LANDMARK COMMISSION

FILE NUMBER: COA-26-000206
LOCATION: 6006 Swiss Ave
STRUCTURE: Contributing

A Certificate of Appropriateness to construct a new accessory building in rear yard.

04/23/26
FOR PERMIT
EXTERIOR ELEVATIONS

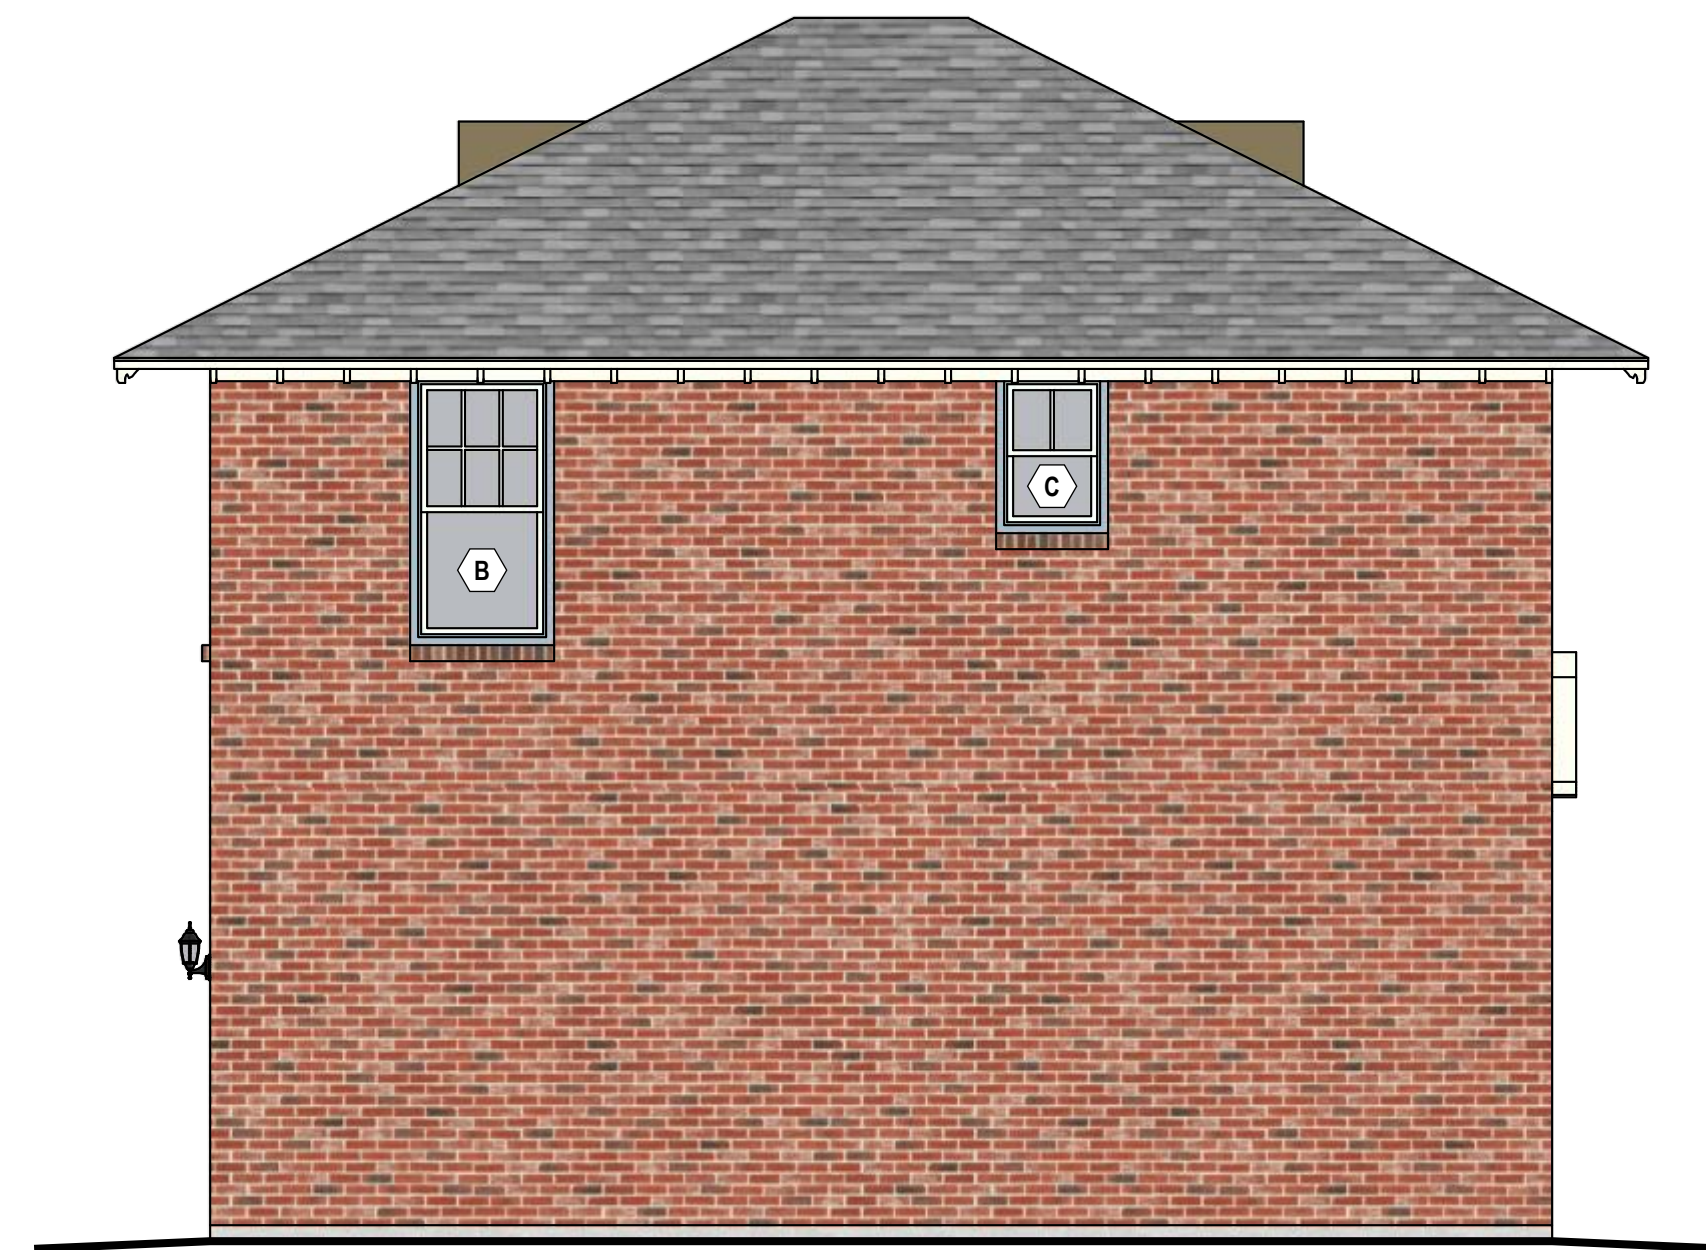
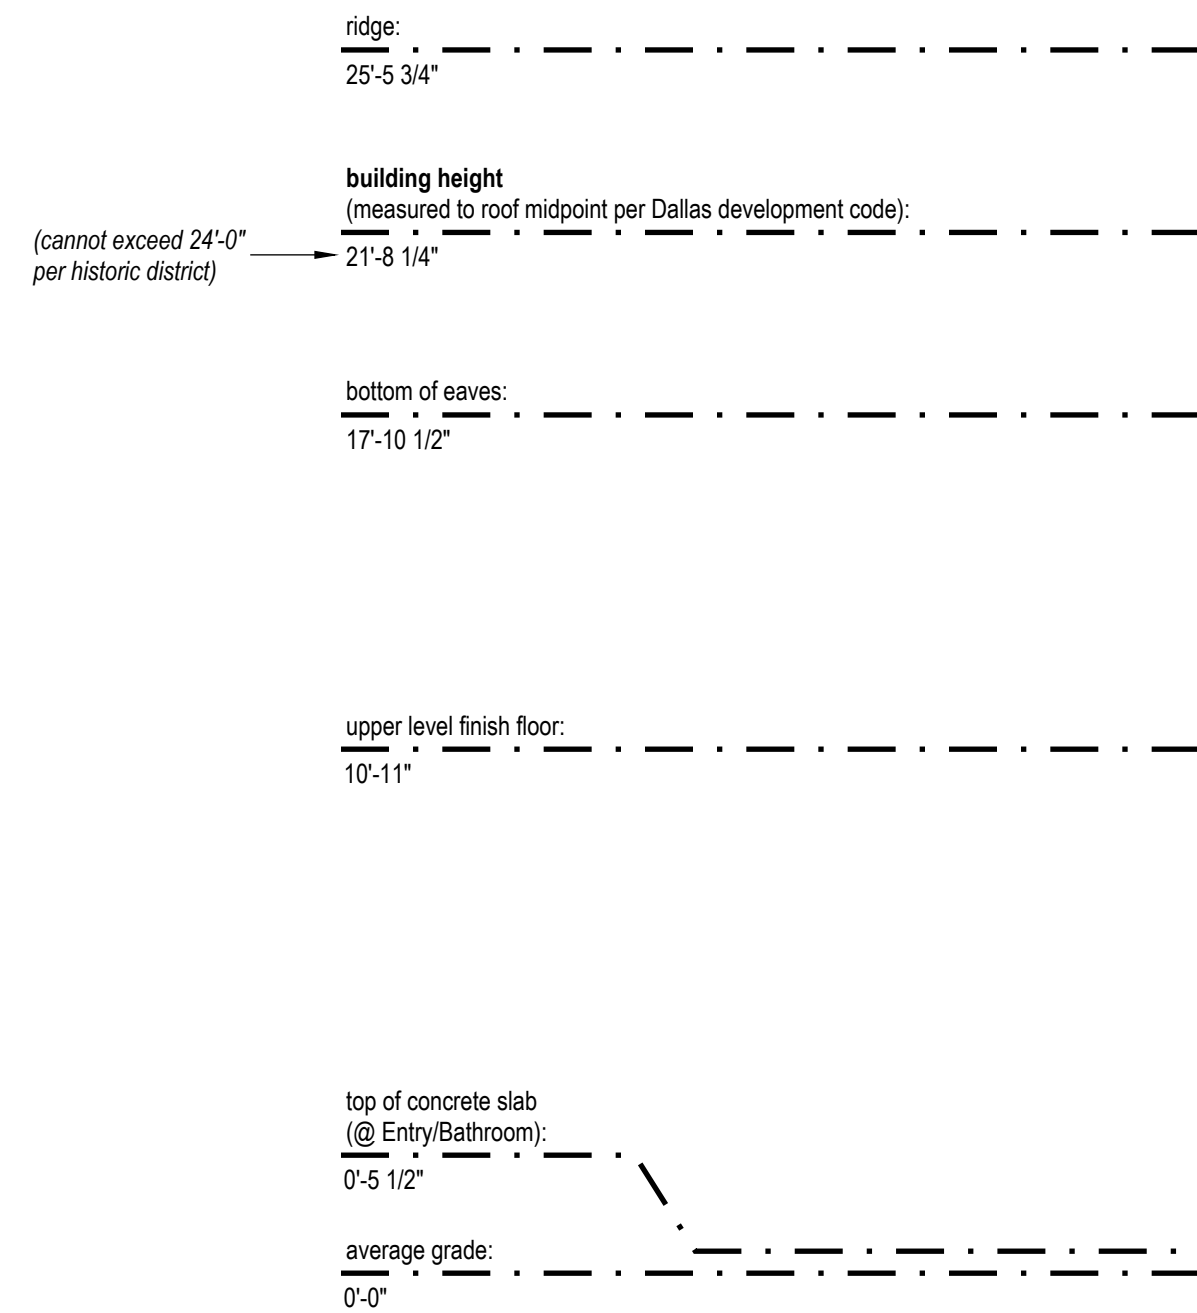
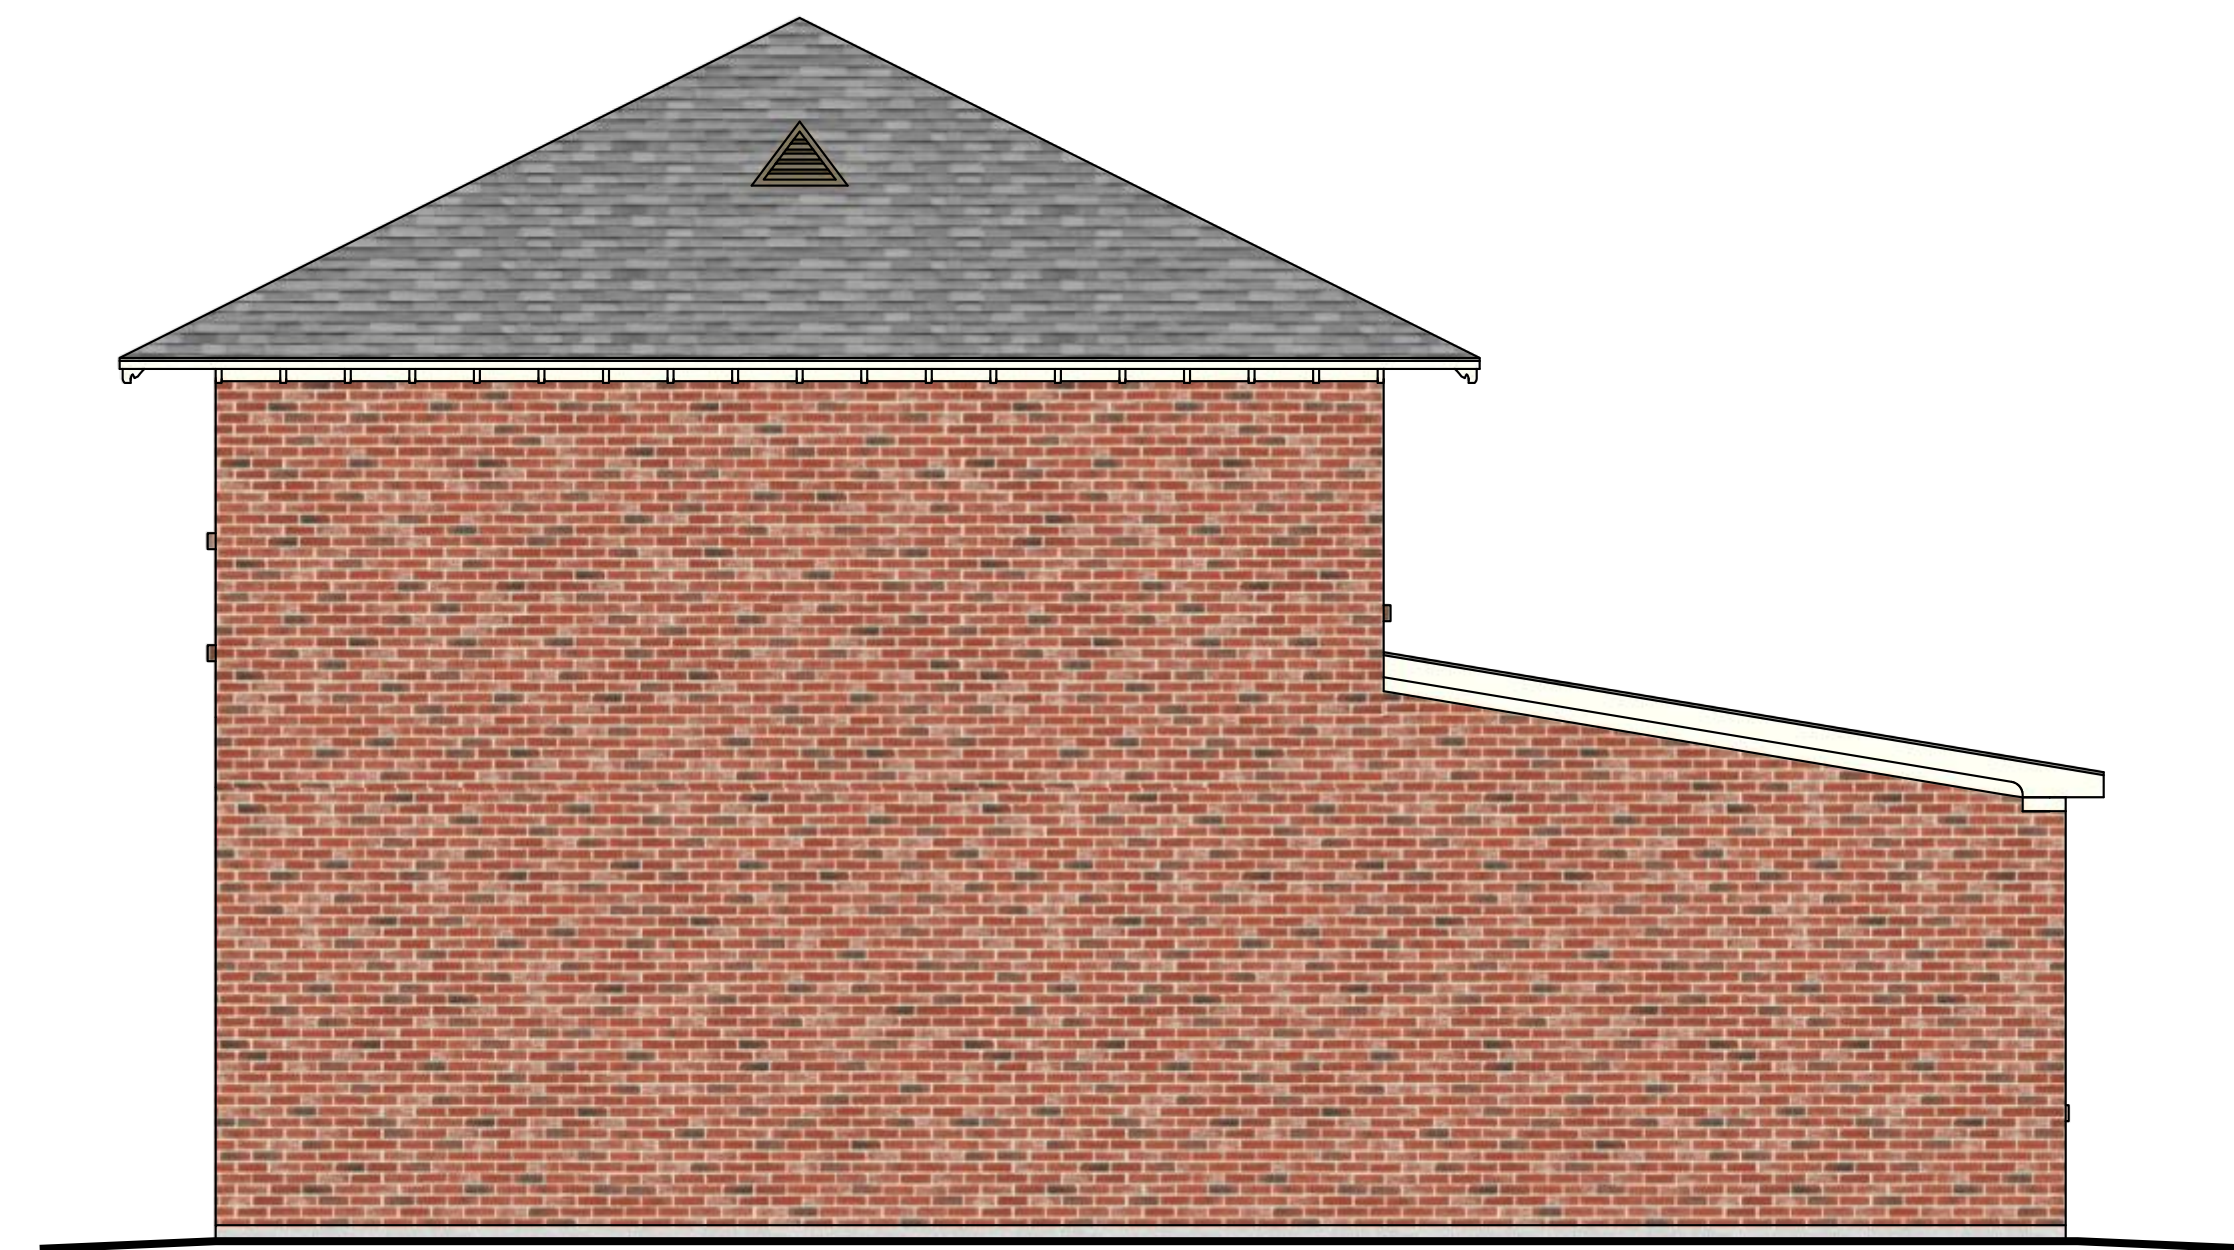
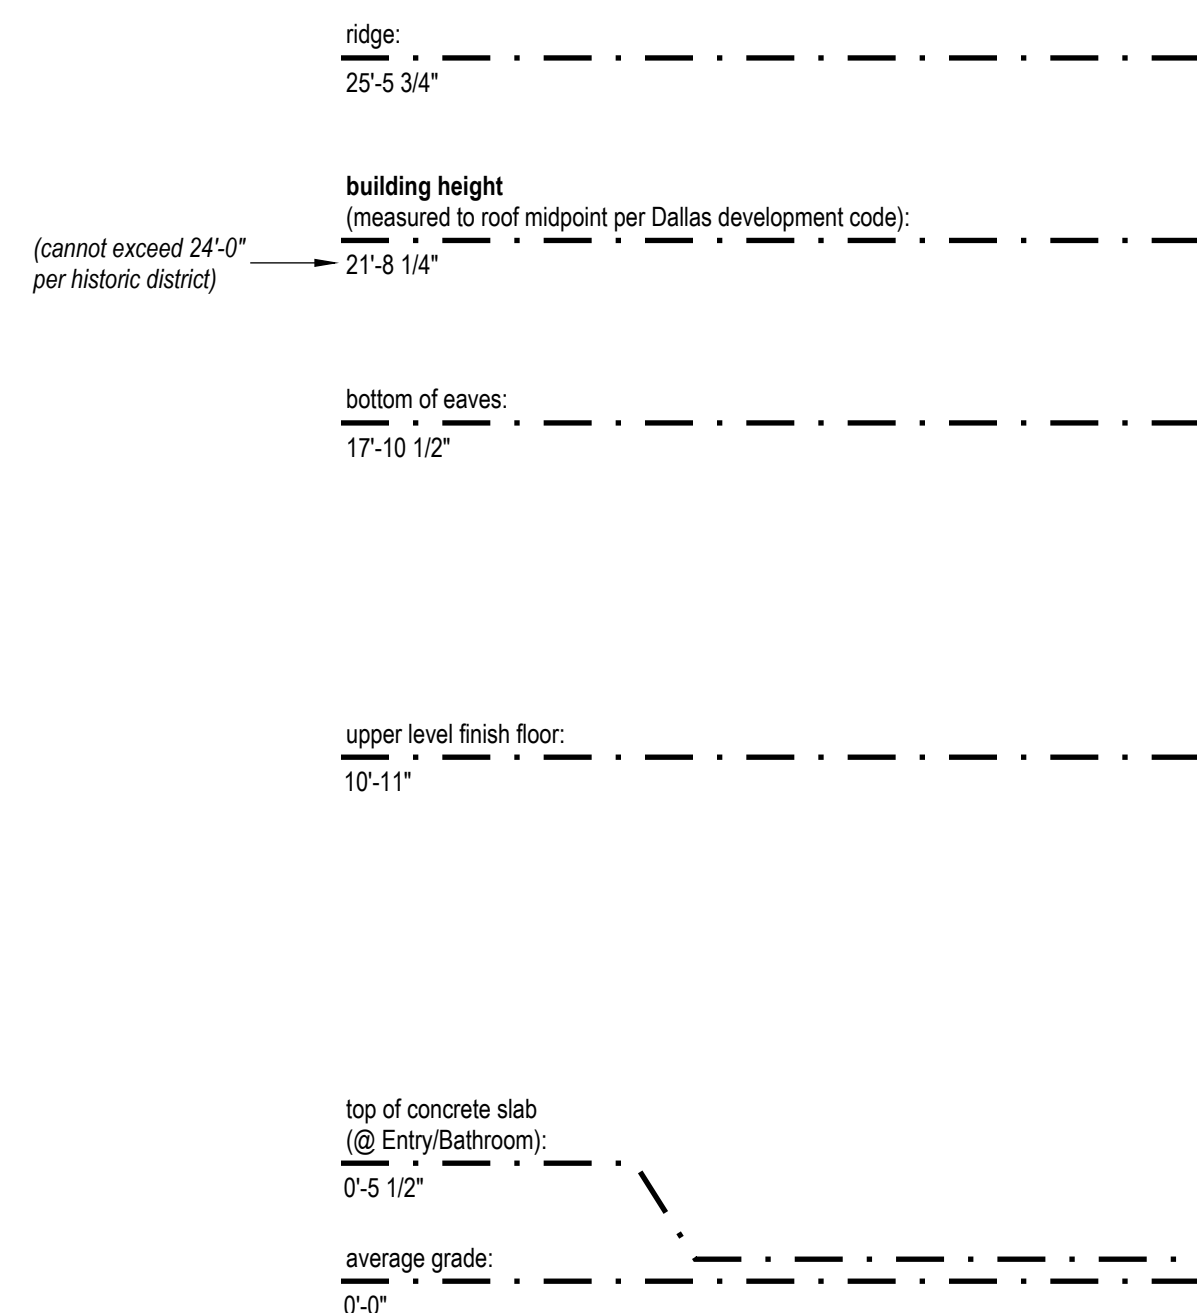
That the request to construct new accessory building in rear yard be approved with the condition that the brick façade material be typical of the style and period of the main structure.

recommend - that the brick facade material be typical of the style & period of the main building.
